Vermont Agency of Transportation
RECEIVED
CK'D BY RK/JW OK'D BY RY
January 14, 2015
RESUBMIT No Approved AsNoted
BY RY DATE 02/05/2015

TOWN OF FAIRFIELD
SOUTH ROAD, FAS 0281 (RURAL MAJOR COLLECTOR)
BRIDGE NO.: 14 PROJECT NO.: BRF 0281(25)

PRECAST ABUTMENT LAYOUT & ELEVATION

1 / F1 PRECAST ABUTMENT LAYOUT
1/4" = 1'-0"

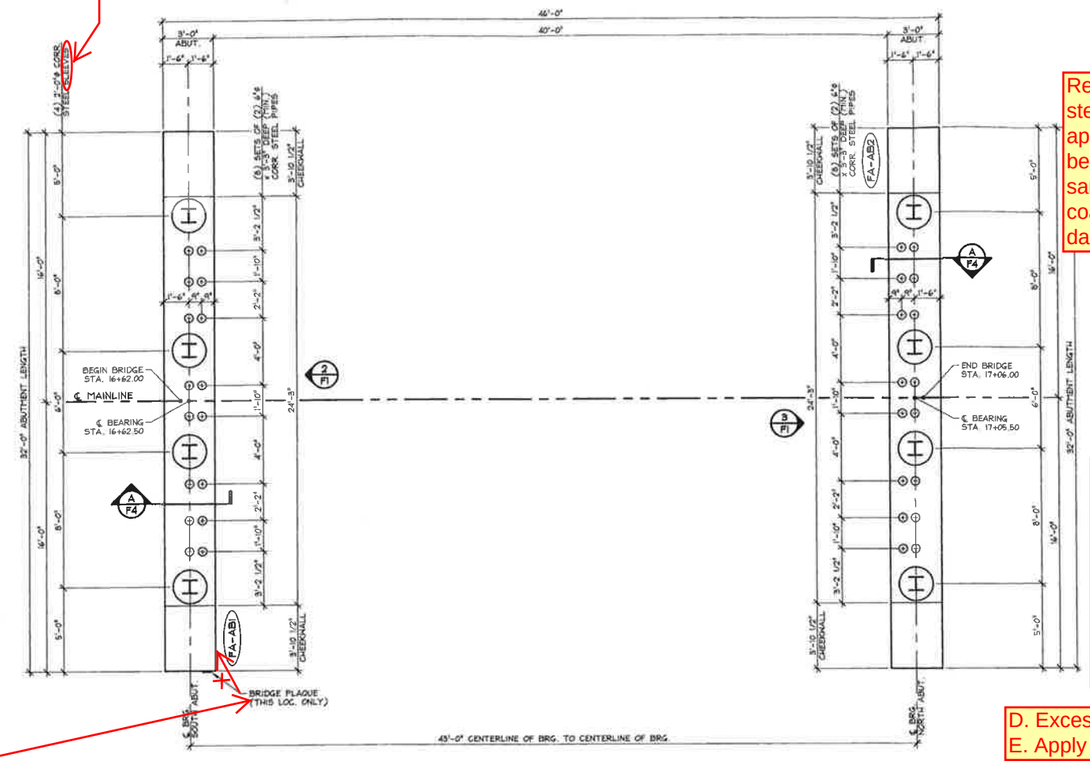
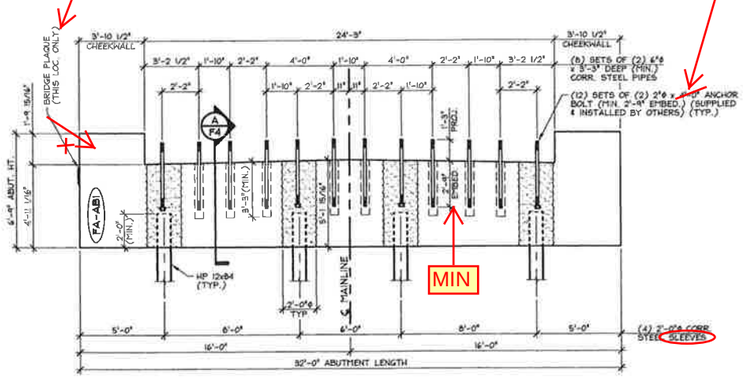
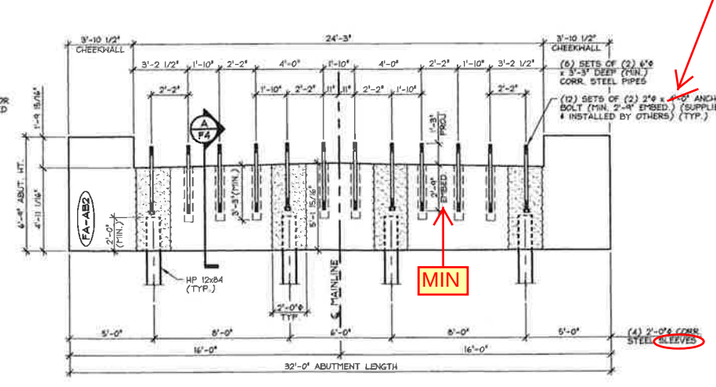
A template shall be used to layout the anchor bolt ducts in the abutments. The same template shall be used to layout the anchor bolt ducts in the solid slabs (required per note 7, sheet 27/69 of contract plans). A template shall be used to layout the #6 approach slab dowels in the abutments. The same template shall be used to layout the dowel ducts in the approach slabs (required per note 2, sheet 28/69 of contract plans). All templates shall be clearly marked to identify location and orientation.

Place on front face so it will not be covered by fill (dimensions for location noted on sheet AB1)

Omit length (determined by others)

1 / F2 PRESTRESSED SOLID SLAB & PRECAST APPROACH SLAB LAYOUT

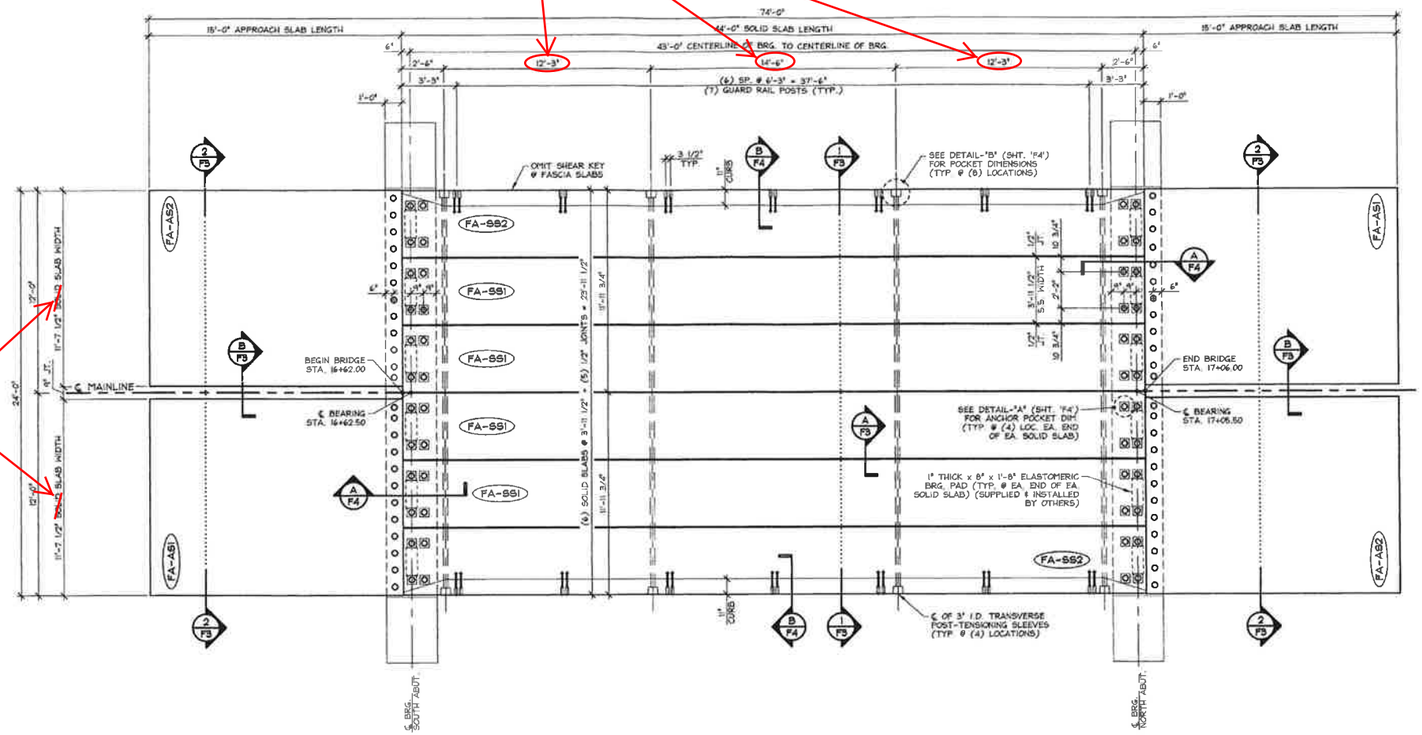
Transverse PT duct spacing should be 12'/15'/12' per sheet 22/69 of contract plans (typ sheets SS1 and SS2)

1 / F3 PRESTRESSED SOLID SLAB TRANSVERSE SECTION
1/2" = 1'-0"

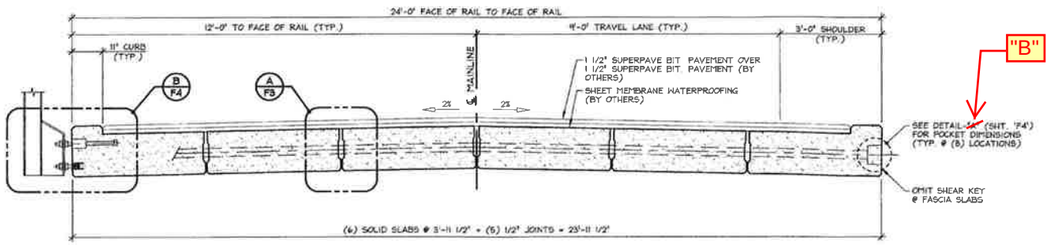
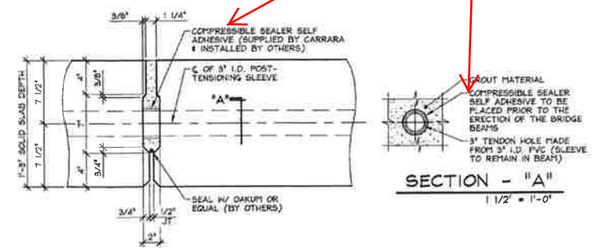
Compressible sealer not necessary per VTrans Structures Design Manual Section 5.3.6.4

DETAIL - "A"

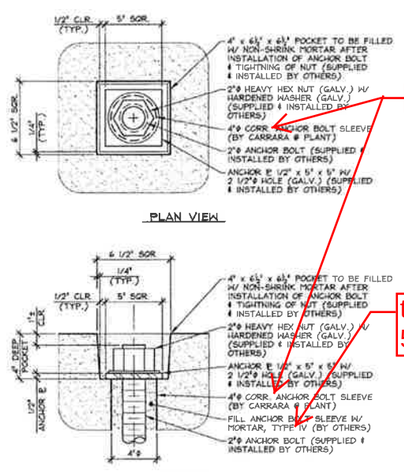
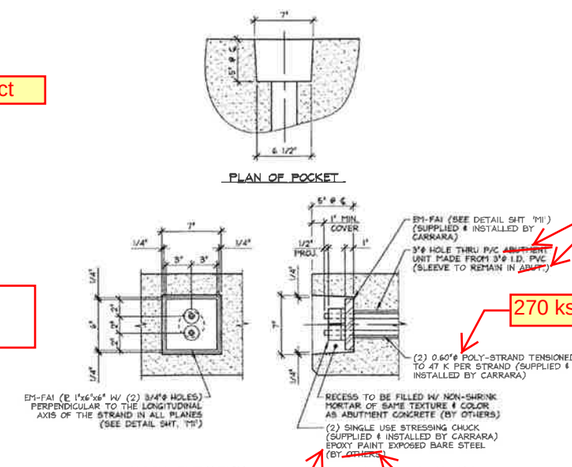
D. Excess tendon length shall be cut using an abrasive wheel.
E. Apply 2 part epoxy to exposed tendon and chuck.

type IV min is 5000psi

270 ksi, low relaxation seven-wire

two part epoxy

1 ABI DIMENSIONAL PLAN VIEW IN FORM
3/8" = 1'-0"

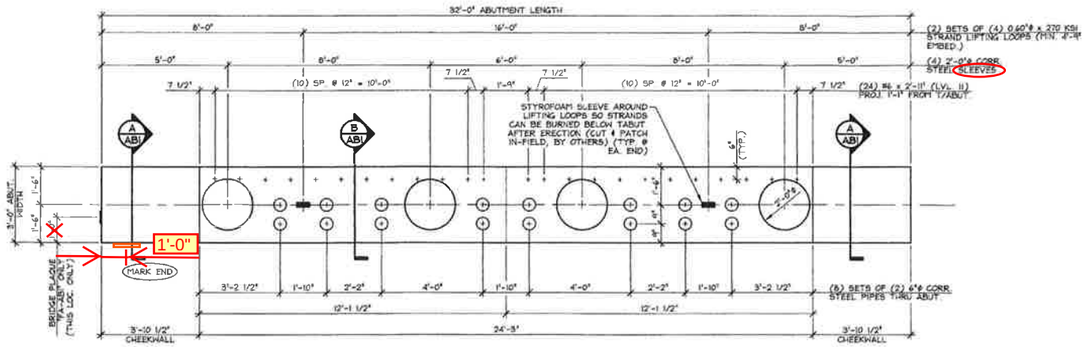
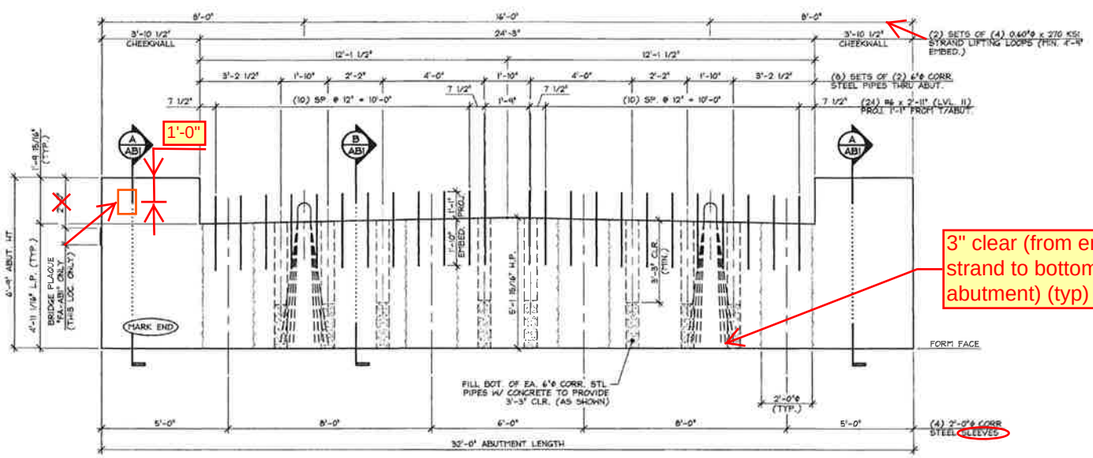
Pipe, AASHTO M 36, Type I

1 ASI DIMENSIONAL PLAN VIEW IN FORM
1/2" = 1'-0"

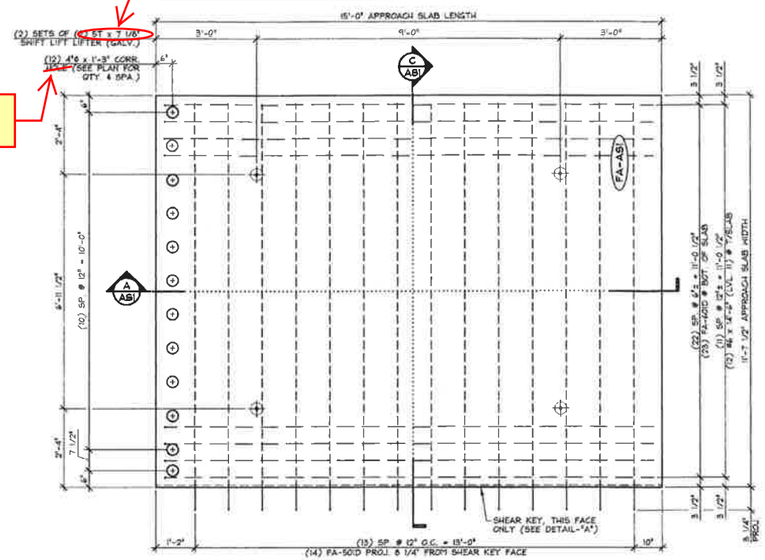
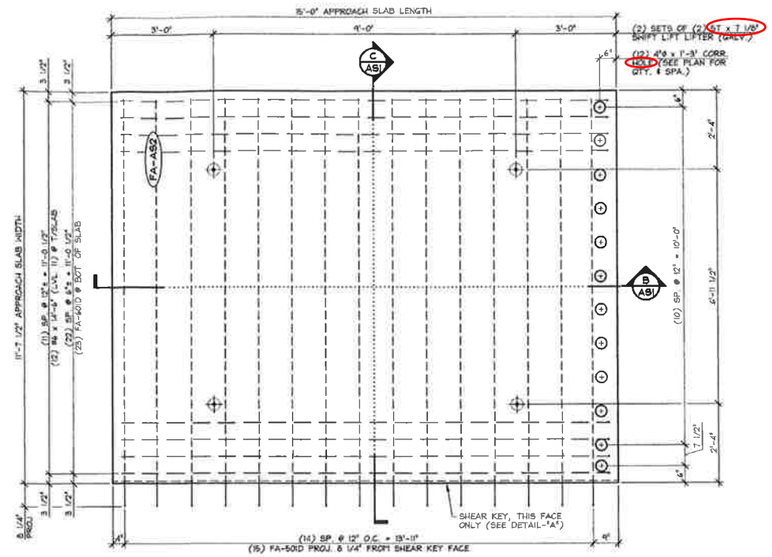
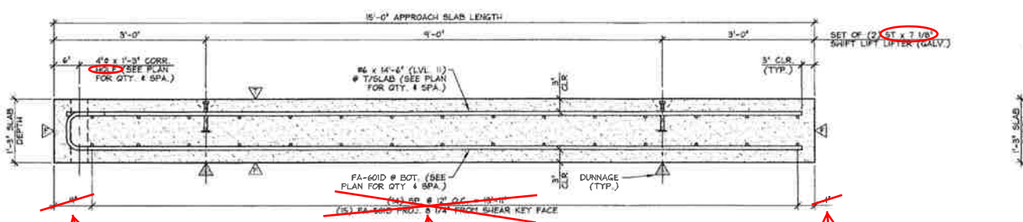
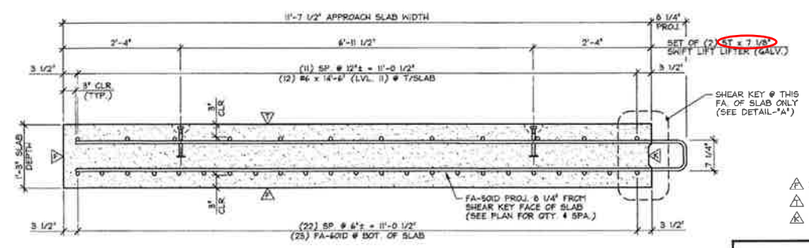
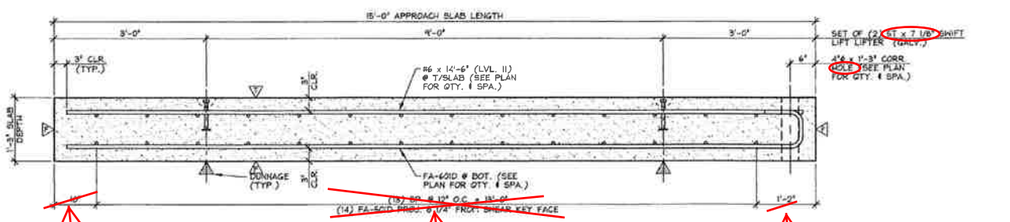
Revise lifting calcs (typ)

Corrugated Post-tensioning duct (material per note 20, sheet 8/69 of contract plans)

1 SSI DIMENSIONAL PLAN VIEW IN FORM
1/4" = 1'-0"

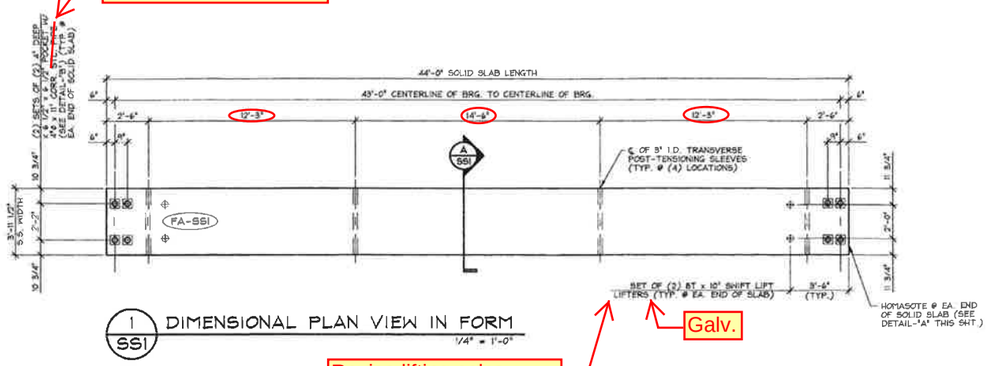
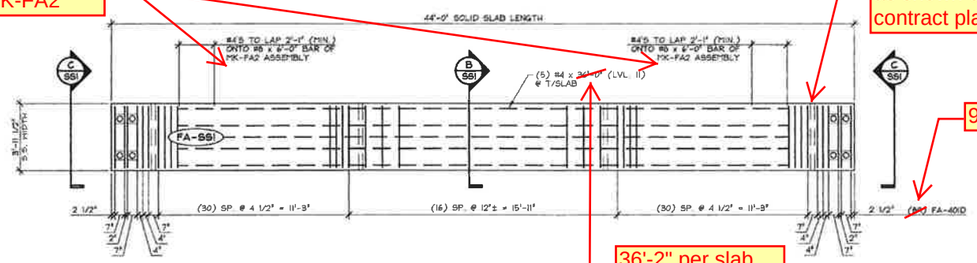
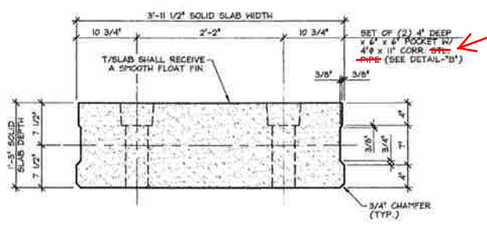
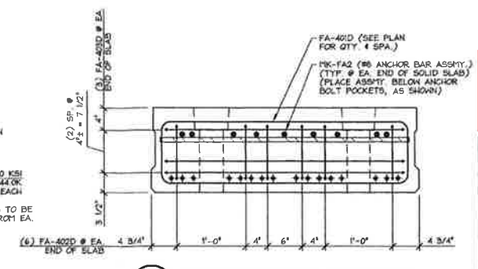
Revise lifting calcs

and lap 8'-1" (min) onto #8 x 12'-0" bar of MK-FA2

Bundle 2 bars each side of duct as shown on sheet 23/69 of contract plans (typ each end)

93 (with bundled bars)

36'-2" per slab elevation on sheet 22/69 of contract plans

Post-tensioning duct (material per note 20, sheet 8/69 of contract plans)

1 SS2 DIMENSIONAL PLAN VIEW IN FORM
1/4" = 1'-0"

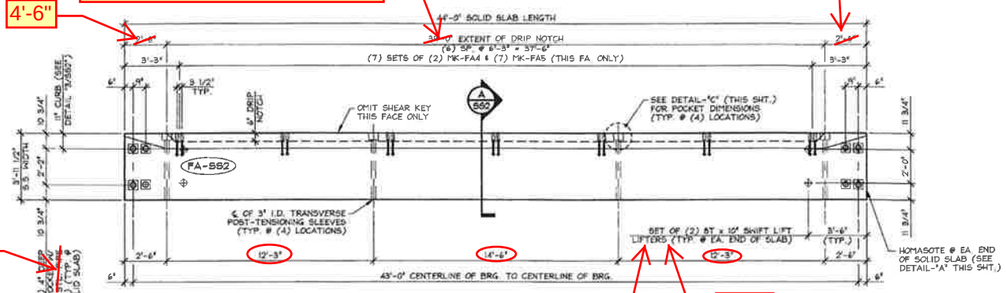
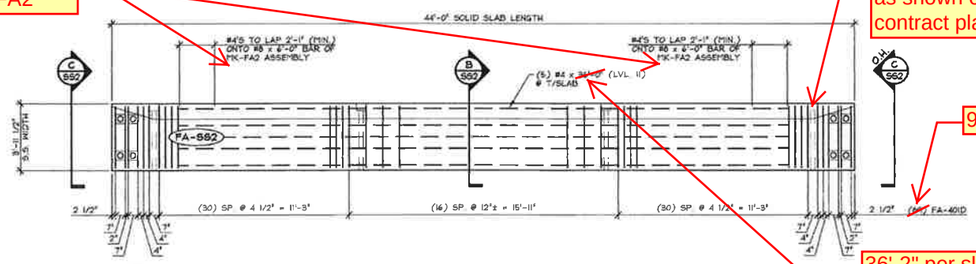
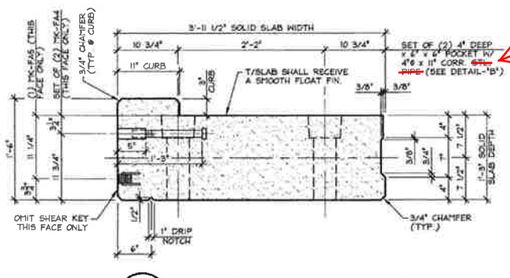
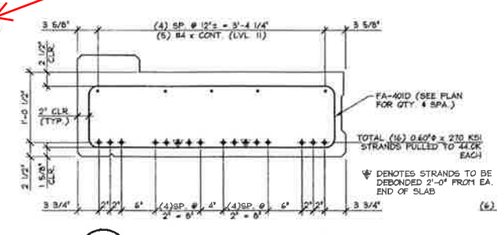
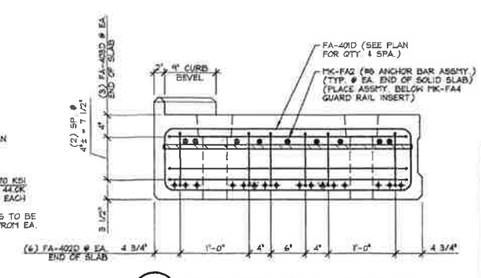
35'-0" (stop 3' from face of abutment per SD-502.00)

Revise lifting calcs

and lap 8'-1" (min) onto #8 x 12'-0" bar of MK-FA2

Bundle 2 bars each side of duct as shown on sheet 23/69 of contract plans (typ each end)

93 (with bundled bars)

36'-2" per slab elevation on sheet 22/69 of contract plans

Post-tensioning duct (material per note 20, sheet 8/69 of contract plans)

M K - F A 2

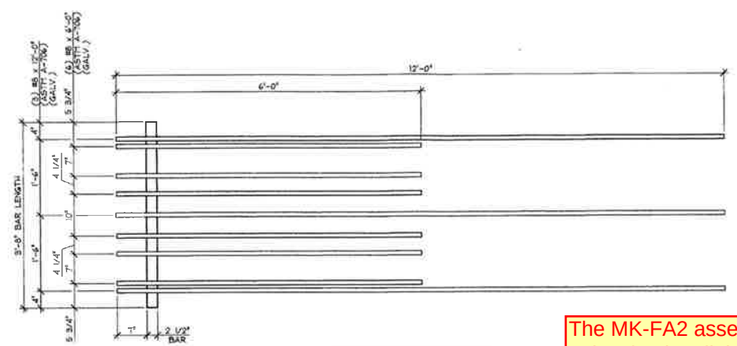
The MK-FA2 assemblies shall not be galvanized until the Agency has visited the plant to inspect the fabrication and given approval to Carrara to proceed with galvanizing the assemblies.

Note: After MK-FA2 assembly has been galvanized, entire assembly shall be coated with two part epoxy repair material in accordance with Level II, Dual Coated reinforcing steel manufacturer instructions.

270 ksi, low relaxation, seven-wire

and epoxy coated

Pipe, AASHTO M36, Type 1
